Access Compliance Report

Public Rights-of-Way

(Curb Ramps)

Intersection ID: 19925	Main Street: SARDIS_RD	Cross Street: PROVIDENCE_RD	Location: NW
ADA ID: 6DDF5139E774	Ramp Type: Perp	Initial Pass/Fail: Fail	Overall Compliance: No
Severity Score: 8.75			
Codes/Mitigation Info/Possible Solution		Field Measurements/Component Compliance

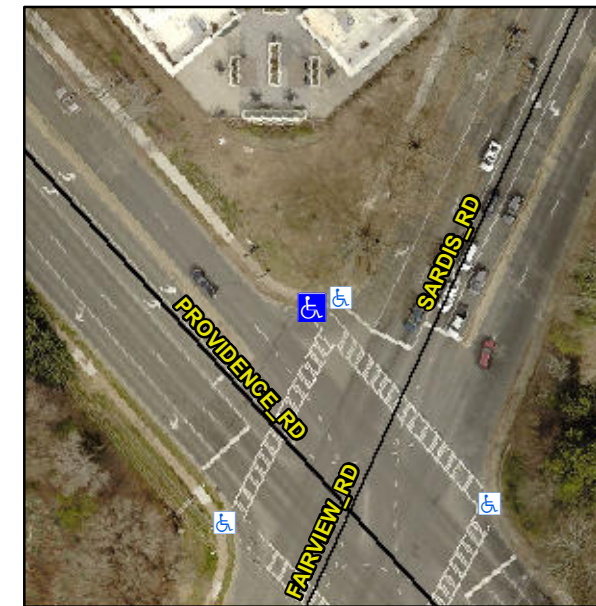
Not Found, R304.5.1

Compliance	Description	Data	Compliance	Description	Data
N/A	Ramp Length (in)	48.0	Yes	Ramp Slope (%)	5.1
No	Ramp Width (in)	42.0	Yes	Ramp XSlope (%)	0.5
N/A	Flare Type LT	N/A	N/A	Flare Type RT	N/A
N/A	Flare Slope LT (%)	N/A	N/A	Flare Slope RT (%)	N/A
N/A	Flare Traversable LT?	N/A	N/A	Flare Traversable RT?	N/A
N/A	Landing Length (in)	N/A	N/A	DWS Provided?	N/A
N/A	Landing Width (in)	N/A	N/A	DWS Contrast?	N/A
N/A	Landing Slope (%)	N/A	N/A	DWS Length (in)	N/A
N/A	Landing X Slope (%)	N/A	N/A	DWS Full Width?	N/A
N/A	Landing Curb? (Y/N)	N/A	N/A	DWS Offset (in)	N/A
N/A	Shared Landing?	N/A			
N/A	Gutter Ponding?	N/A	N/A	Gutter Slope (%)	N/A
N/A	Gutter Lip Ht (in)	N/A	N/A	Gutter X Slope (%)	N/A
N/A	Painted X Walk1?	Yes	N/A	Painted X Walk2?	N/A
	X Walk 1 Direction	To SW		X Walk 2 Direction	N/A
N/A	X Walk 1 Width (in)	108.0	N/A	X Walk 2 Width (in)	N/A
	X Walk 1 Slope (%)	1.0		X Walk 2 Slope (%)	N/A
	X Walk 1 X Slope (%)	0.3		X Walk 2 X Slope (%)	N/A

Remove & Replace Entire Ramp.
